**Field Safety Notice  
Notification Update**

**CombiDiagnost R90 and ProxiDiagnost N90**

Component damage due to short circuit & table stop due to broken tabletop cable

February 2023

Figure 1. Image of damaged cable

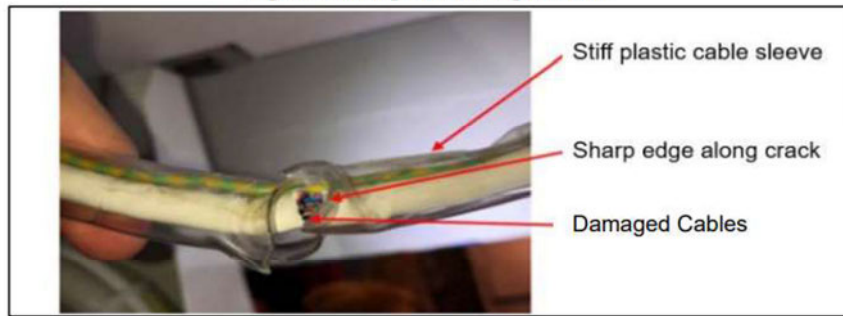
On the ProxiDiagnost N90 table there is a cable located under the tabletop that is covered by a plastic sleeve which can crack and damage the cable (see Figure 1). If the tabletop cable is damaged or breaks, the user may not be able to initiate table tilting movements. However, if the cable breaks, the braking mechanism is released, but the system is counterbalanced in all directions which prevents movement of the table. The table can still be brought back to 0° position using the Tilting Switch and the patient can be safely moved off the table.

A Philips Field Service Engineer (FSE) will visit impacted customer sites to replace the tabletop cable to prevent the issue from occurring.
